UNITED STATES
NUCLEAR REGULATORY COMMISSION
WASHINGTON, D. C. 20555

APPLICANT: Public Service Electric & Gas Company (PSE&G)
FACILITY: Hope Creek Generating Station
SUBJECT: SUMMARY OF STRUCTURAL AND GEOTECHNICAL ENGINEERING
BRANCH (SGEB) MEETING

On August 1, 1984, a meeting was held in the Bethesda, Maryland offices of the NRC to discuss the remaining SGEB-Structural audit open items identified in the Draft SER. A list of meeting attendees is included as Enclosure 1 to this meeting summary.

FIGURE A-13-20
 RESPONSE SPECTRA COMPARISON,
 UNIT 1 REACTOR BUILDING AT ELEV. 54' - 0"

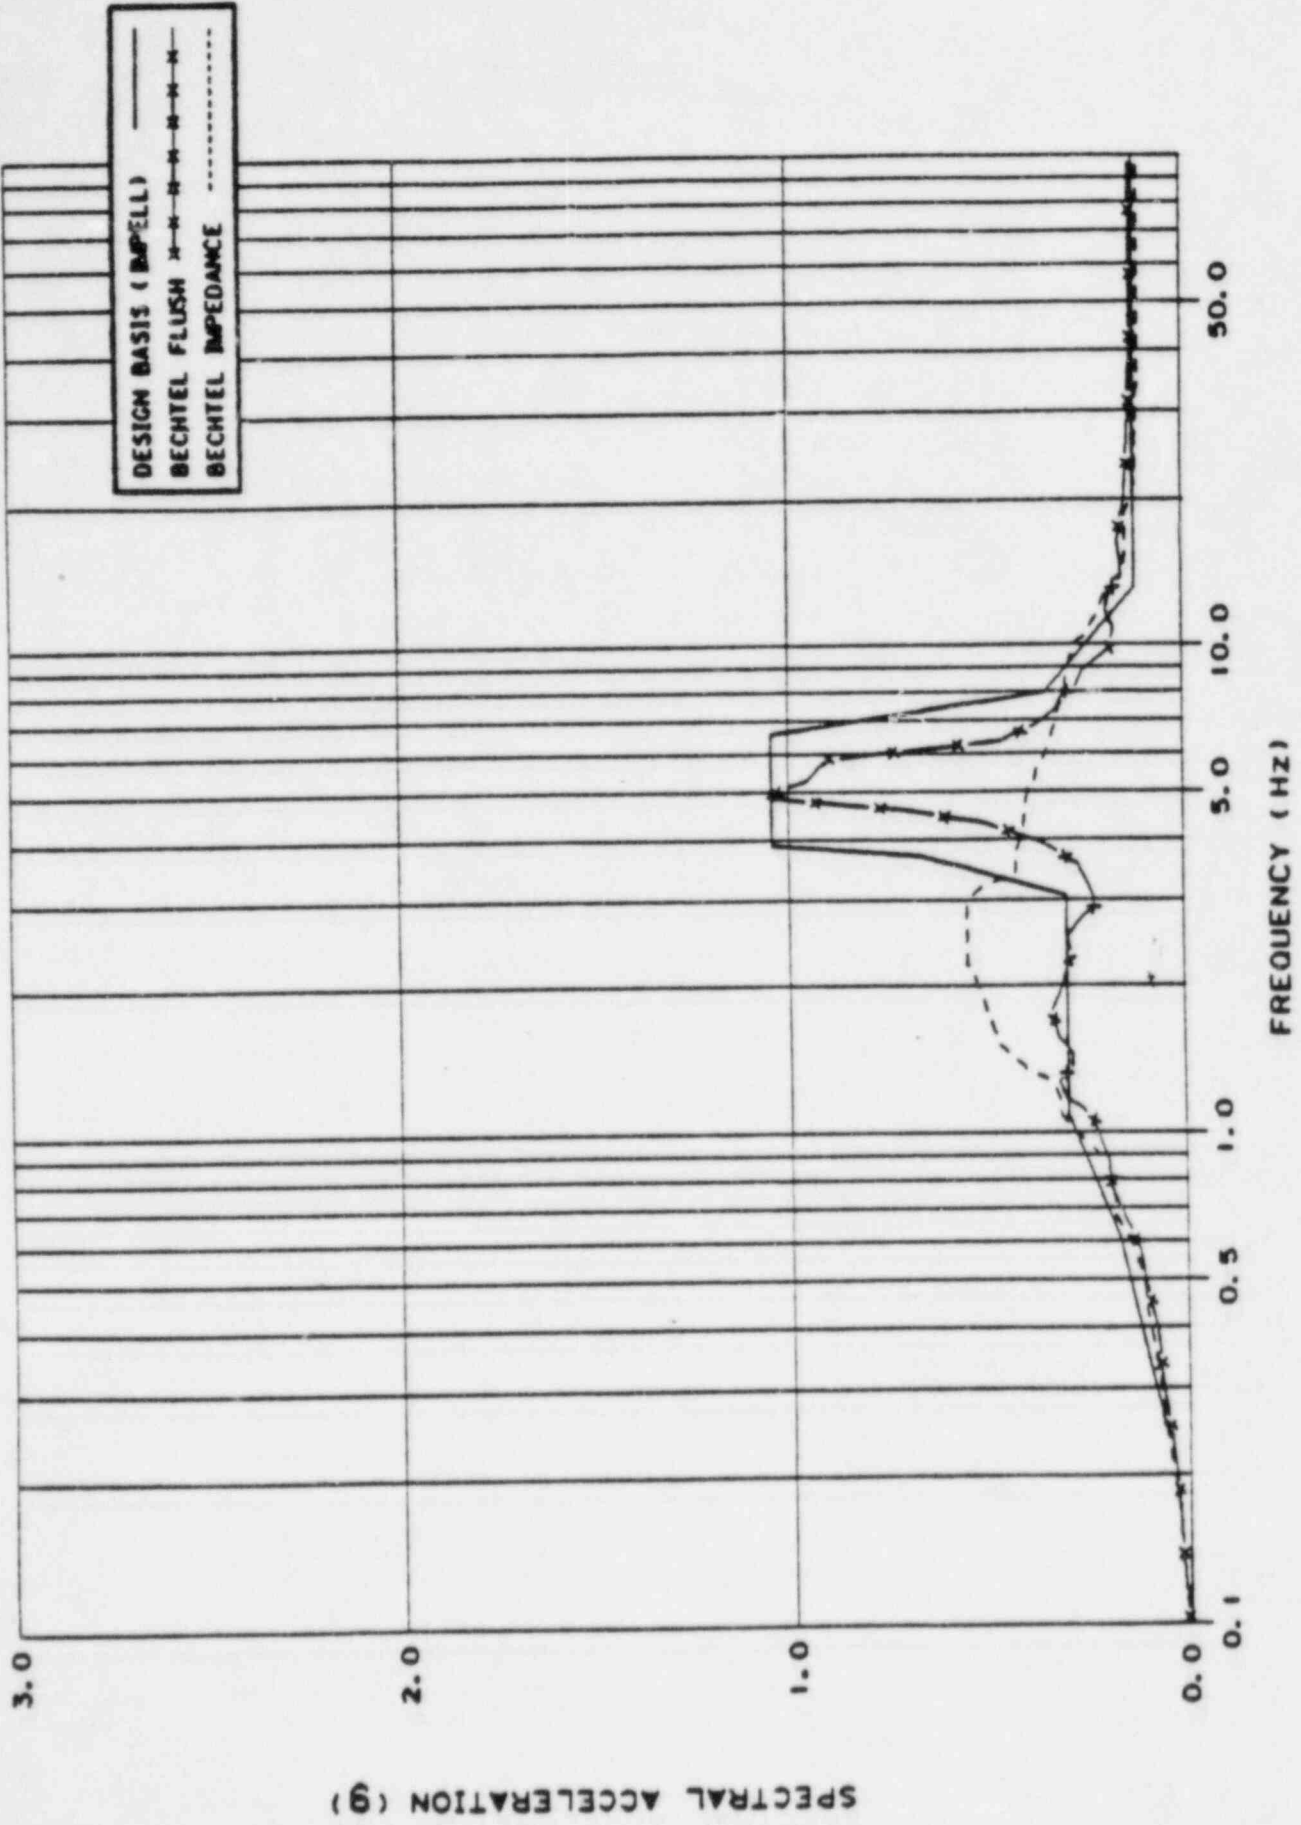
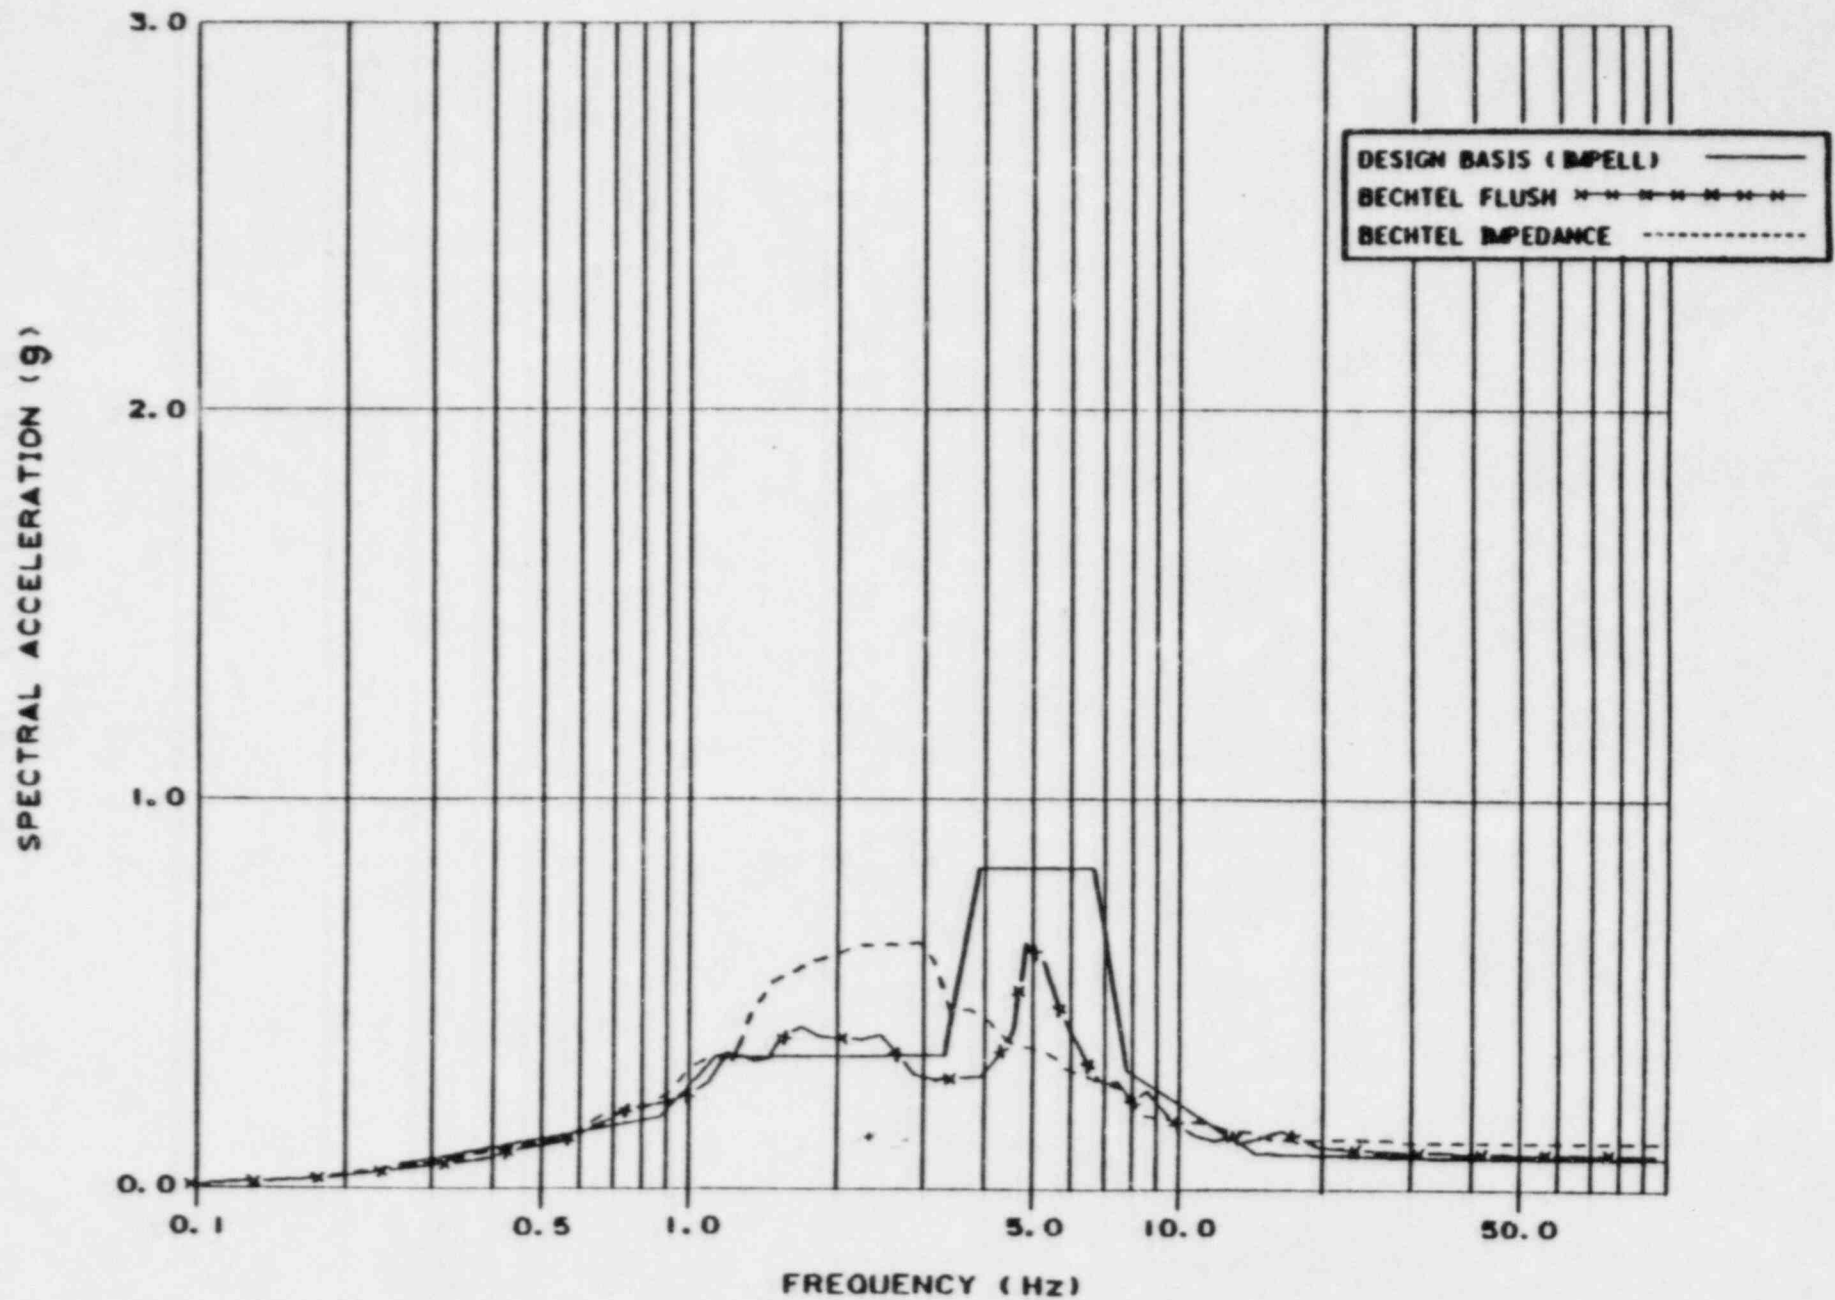
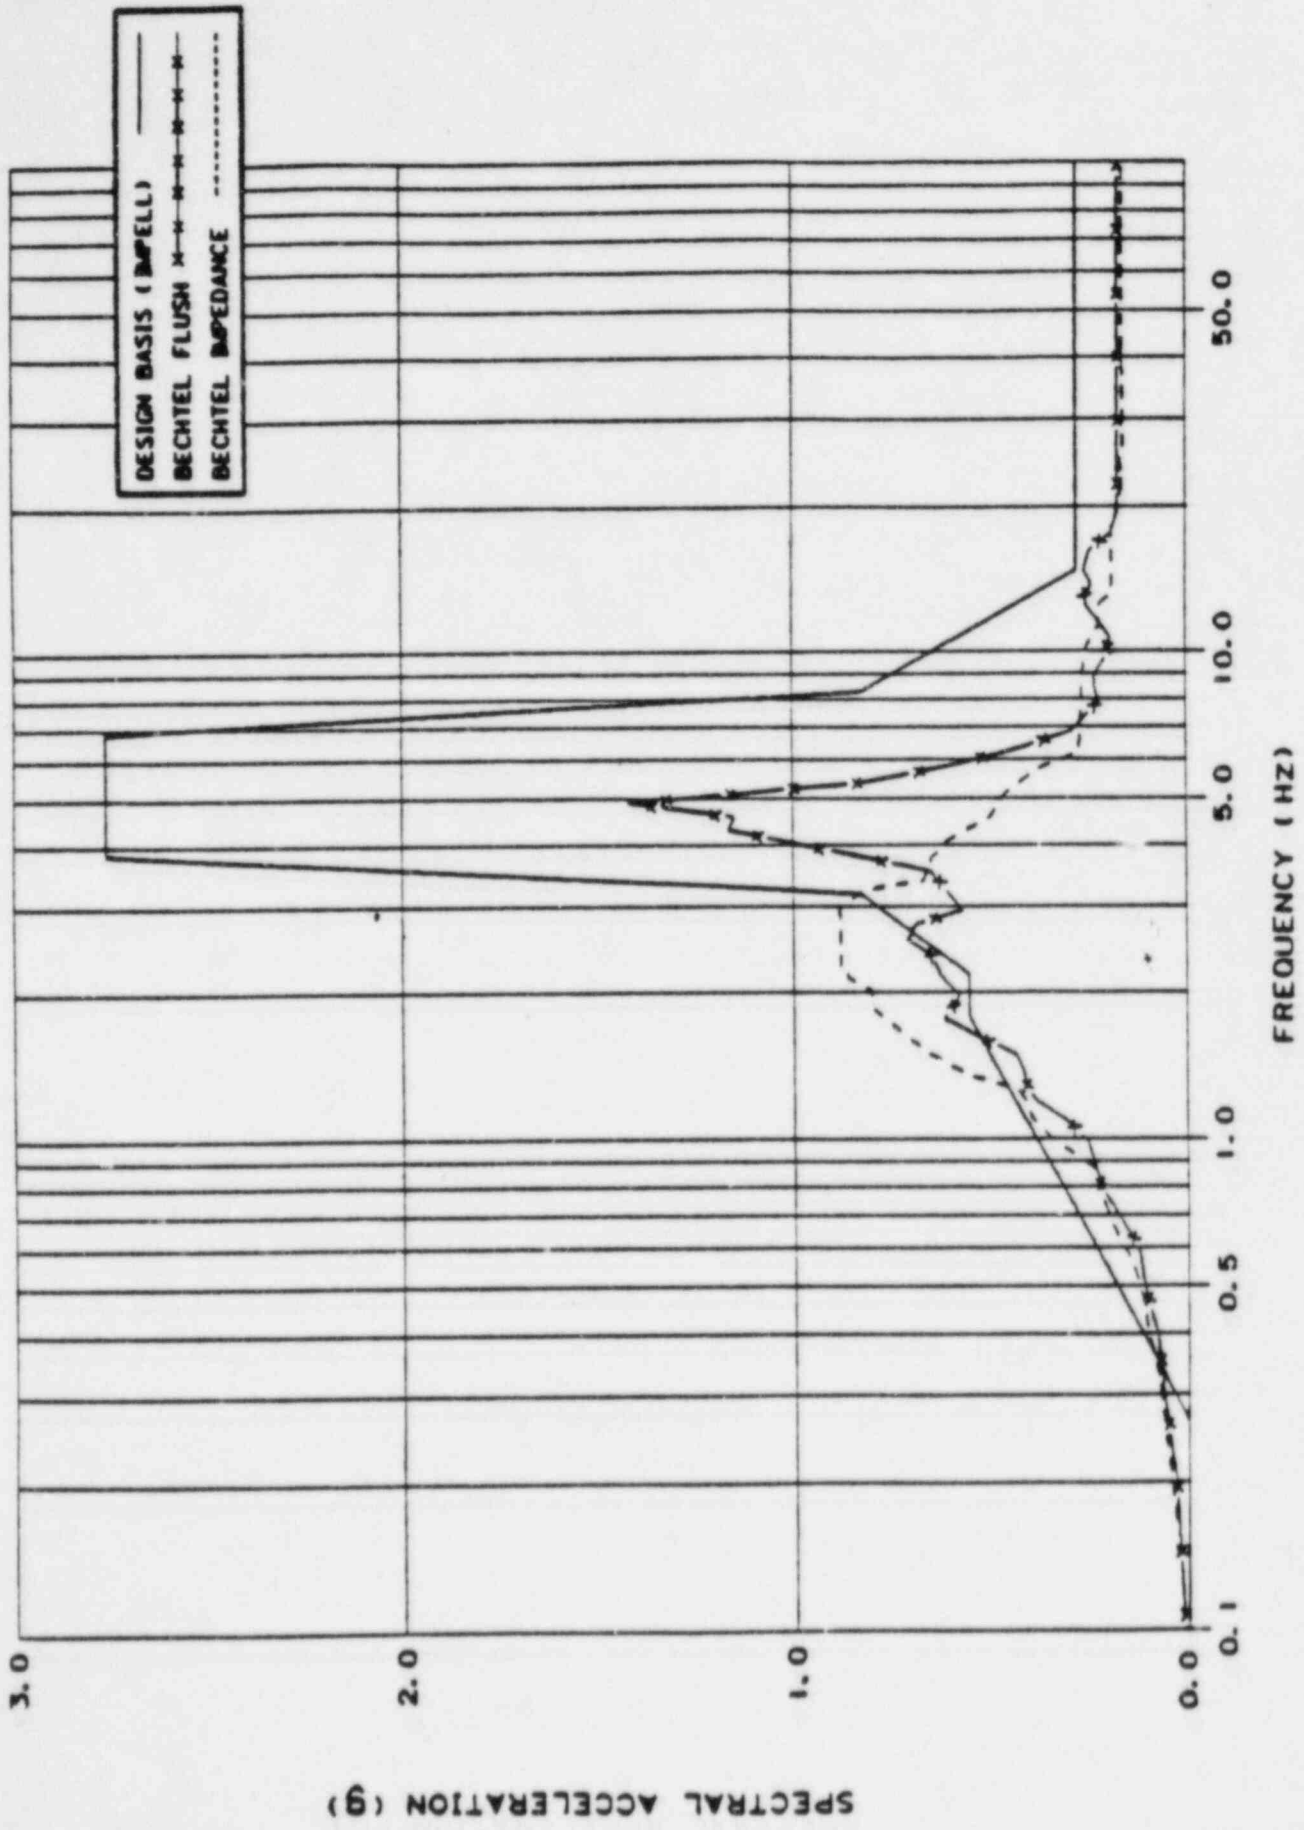
Question: Provide comparison of Bechtel Independent Verification Results with the Design Basis Results.

Figures A-13-2 to A-13-37 show the comparison of the response spectra (2% damping) obtained from the above three seismic soil-structure interaction analyses. Discussions of these comparisons are as follows:

Bechtel's independent soil-structure interaction analyses are performed using the computer code FLUSH. The results of independent finite element analyses are in reasonable agreement with those of the design basis analyses. As can be seen from Figures A-13-2 through A-13-37, the horizontal response spectra obtained from the independent finite element analyses are generally enveloped by those obtained from the design basis analyses except for the frequency range lower than 2 Hz. The vertical response spectra showed some exceedances at the frequency range of 18 Hz. These exceedances are listed in Table A-13-1.

The peak spectral accelerations obtained from the impedance approach analyses are generally lower than those obtained from the design basis analyses. However, these response spectra are not completely enveloped by those obtained from the design basis analysis, especially in the frequency range between 1.0 and 3.5 Hz. Also, there are some local exceedances in the higher frequency range, as shown in Figures A-13-2 through A-13-37.
